SUBJECT: STABILIZER TRIM STOP/SCREW MODIFICATION

MODEL/S/N AFFECTED: M20J - S/N 24-0001 THRU 24-1694 & 24-3000 THRU 24-3172  
M20K - S/N 25-0001 THRU 25-1230  
M20L - S/N 26-0001 THRU 26-0041  
M20M - S/N 27-0001 THRU 27-0058

FIGURE SI M20-88-1

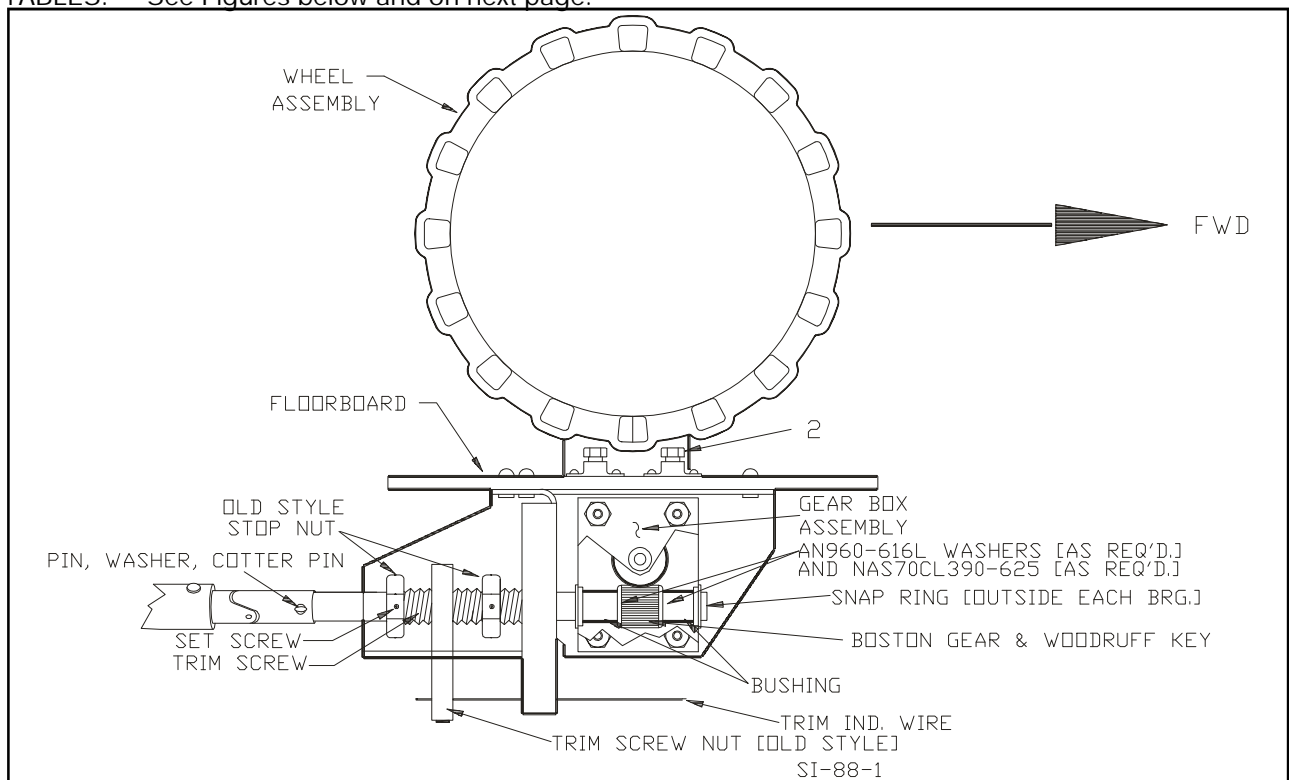
4. Remove cotter pin, washer and pin that secures trim tube universal joint to trim screw (Figure SI M20-88-1).
5. Loosen gear box bolts (Index 1, Figure SI M20-88-2) if not already done, and both NAS428-3-4 bolts (Index 2, Figure SI M20-88-2) to give slack in roller chain between upper and lower sprocket of trim control wheel assembly.

7. Remove roll pin, P/N RPA52-028-125-1125 holding lower sprocket, P/N 740049, to gear box shaft. Remove sprocket.
8. Loosen set screw, #6-32 x 1/8, in each existing trim stop so they will unscrew easily. Remove aft trim stop (DN stop) from trim screw (Fig. SI M20-88-1).

12. Measure and document lateral free play in trim screw shaft (length wise play) as assembled in the gear box assembly.
13. Remove forward snap ring from trim screw. Reference Figure SI M20-88-1
14. Lightly tap trim screw at forward end, with a plastic mallet, to drive trim screw, bushings, washers, gear and aft bearing from gear box assembly housing. Bearings are installed with locktite (Blue) at assembly, so some effort may be required to break it loose. **DO NOT DAMAGE BEARING NOR HEAT THE HOUSING.**
15. When existing trim screw, and components attached to it, comes free from gear box housing, the bushings, washers, gears, woodruff key, snap ring and aft bearing will be removed. Retain components, except woodruff key, to place back on new trim screw (Fig. SI M20-88-1).

16. Install existing snap ring, P/N NAS51-37 on mid groove of new trim screw, P/N 740016-019. Reassemble shim(s), bearing, bushing, washer(s), Boston gear, new woodruff key, washer(s) and spacer on new trim screw.

FIGURE SI M20-88-2

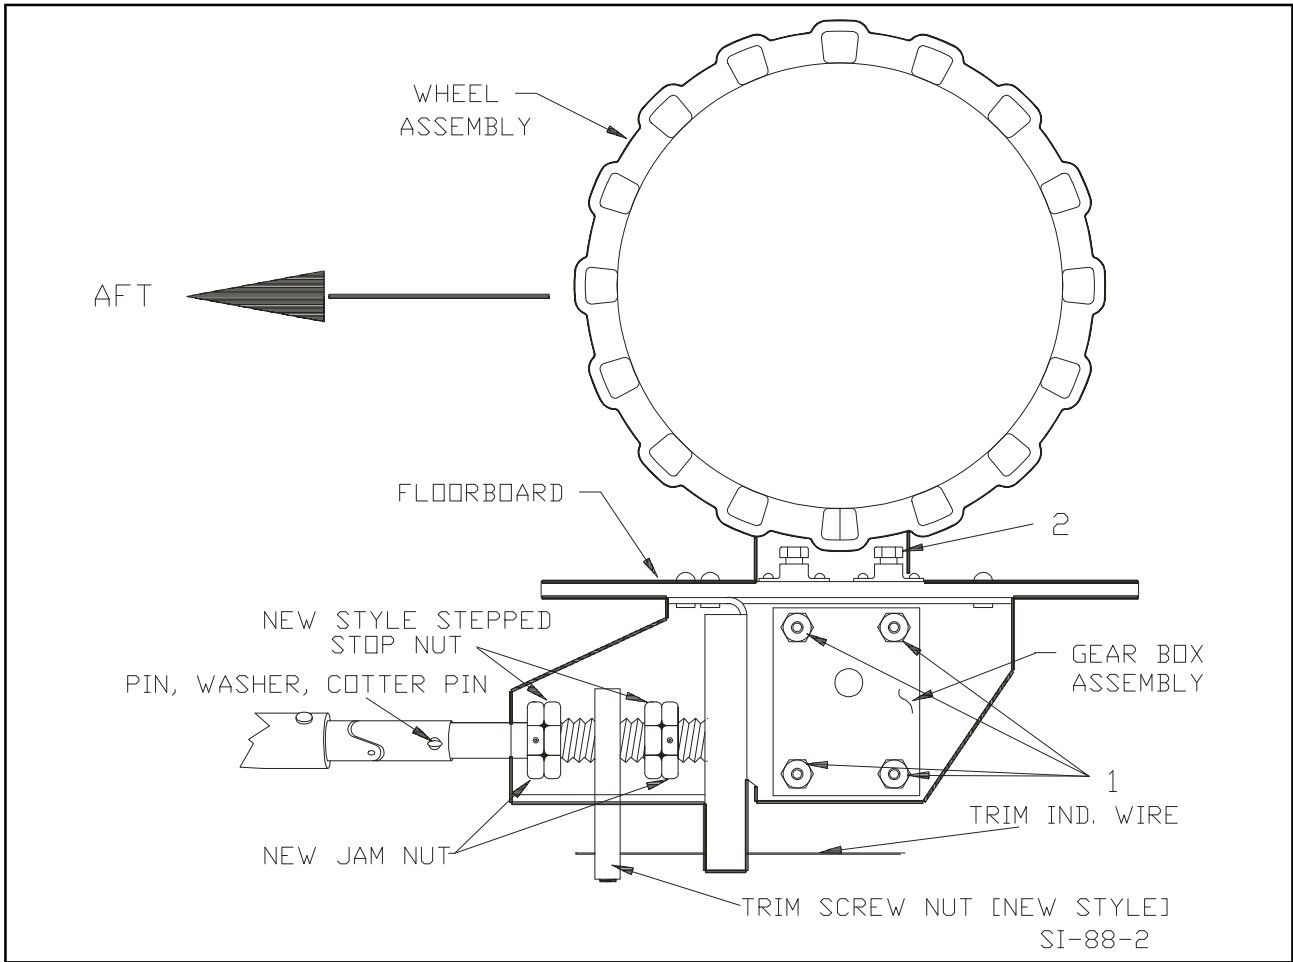
1. Remove belly access panels or smooth belly fairing to gain access to lower side of the trim control wheel assembly.
2. Remove trim indicator wire from trim screw nut by loosening set screw(s) that restrain trim wire.
3. Remove any brackets connected to gear box bolts (Index 1, Figure SI M20-88-2) both sides if required. Different models have different type of brackets.

22. Install one jam nut (UP stop side), P/N 740086-003 (M20J) or 740086-001 (M20K, M20L or M20M), on trim screw. Screw toward gear box housing leaving approximately 0.375 inch gap on threads between gear box and jam nut (Figure SI M20-88-2).
23. Install one stepped stop nut (UP stop), P/N 740086-007 (M20J) or 740086-005 (M20K, M20L or M20M) on trim screw. Screw toward gear box housing and against jam nut installed in step 22.

27. Reverse Steps 2 thru 7 to reposition gear box assembly back on trim wheel assembly. Do not tighten trim indicator wire set screw at this time. Position all other brackets but do not tighten bolts holding gear box assembly to trim wheel assembly (Fig. SI M20-88-2).
